# Model Error Resolution Document

1. Originator: Jerry McNeish	2. Date: June 24, 2008	3. ERD No. MDL-WIS-PA-000005 ERD 04
4. Document Identifier: MDL-WIS-PA-000005 REV 00 and AD 01	5. Document Title: Total System Performance Assessment Model/Analysis for the License Application

### 6. Description of and Justification for Change (Identify applicable CRs and TBVs):

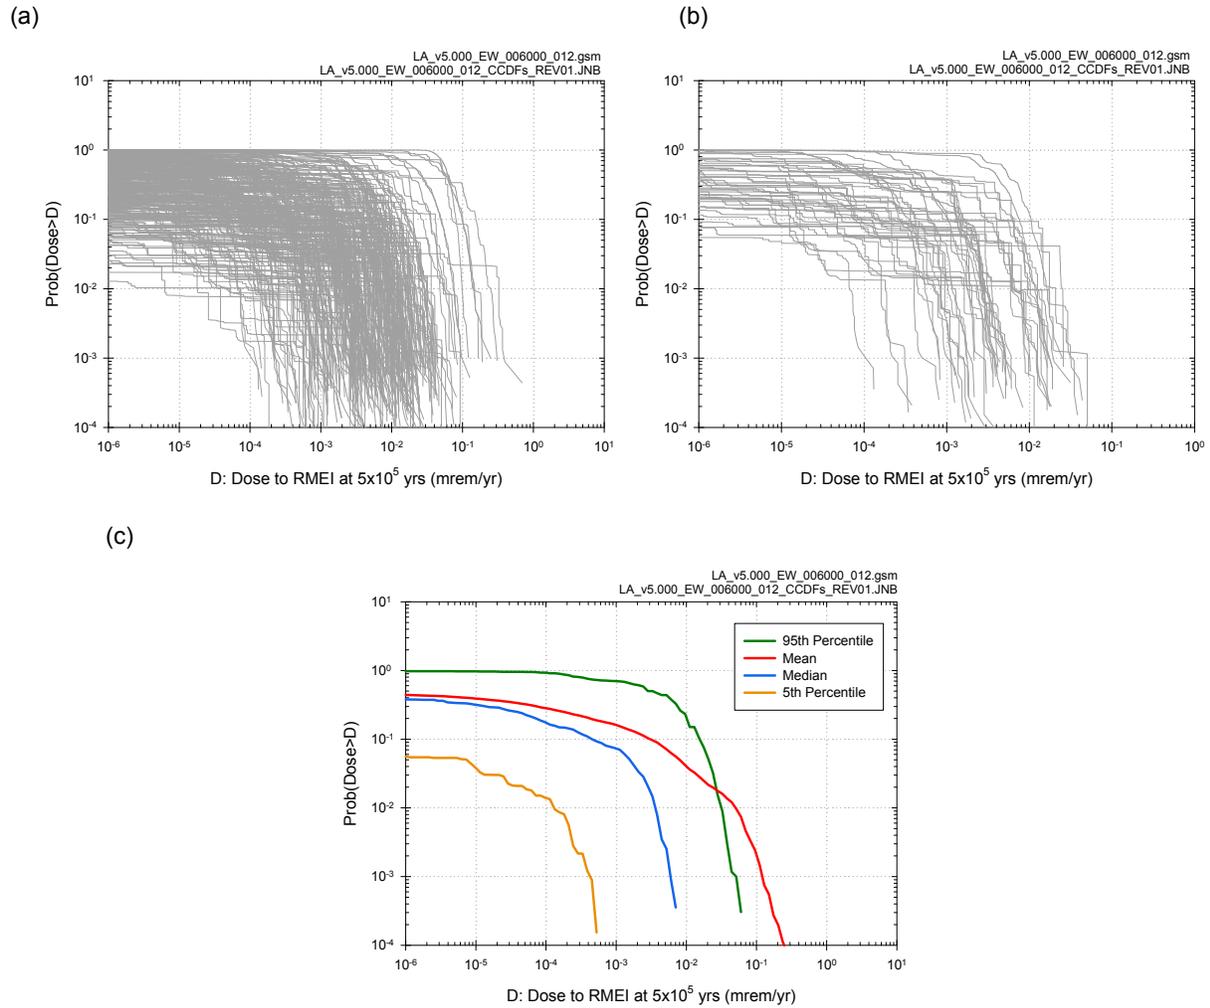
In Appendix J of the TSPA-LA document (Rev00), it has been discovered that several of the plots/figures are not displaying all the data that was available in the SigmaPlot file. The discussion and captions regarding the figures are correct, however, the plots themselves are only showing approximately 160 realizations when they should be displaying 300 realizations. Attachment 2 provides the replacement plots (part (a) on each figure) with all 300 realizations, and the SigmaPlot files are in output DTN: MO0806TSPADCOR.000. Only the figures themselves are affected by this change, therefore, there is no impact on the results or conclusions of the TSPA-LA or SAR.

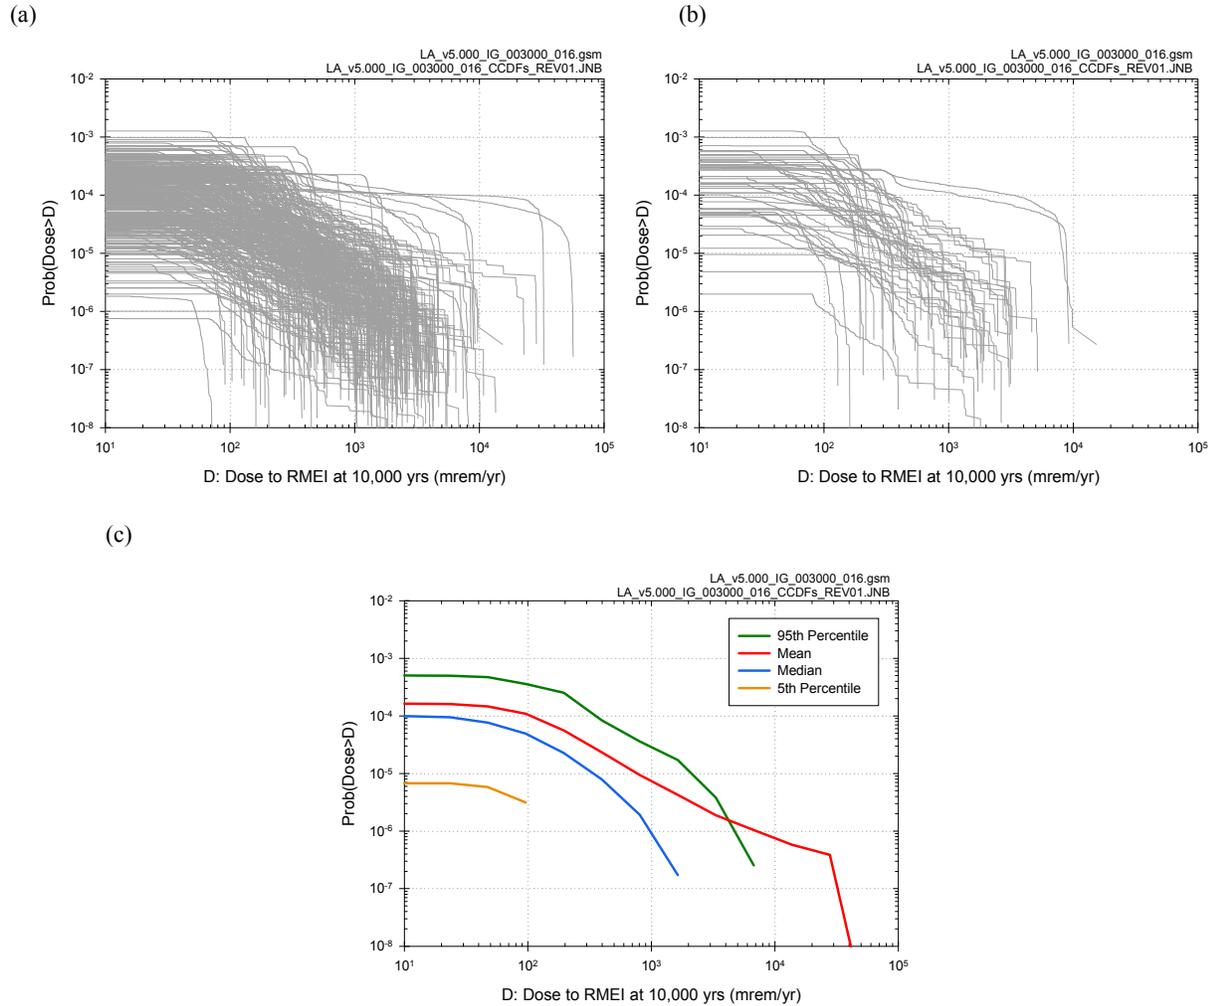
In Appendix J of the TSPA-LA document, a duplicate figure was discovered in Figure J7.2-9 on page FJ-63. The plot illustrated in (b) is the same plot shown in (a). The figure and results are described correctly in the caption and text. However, plot (a) shows 300 realizations, while plot (b) was supposed to show only 50 realizations as indicated in the caption. The entire figure should be replaced with the corresponding one in Attachment 2. There is no impact on results or conclusions of the TSPA-LA or SAR.
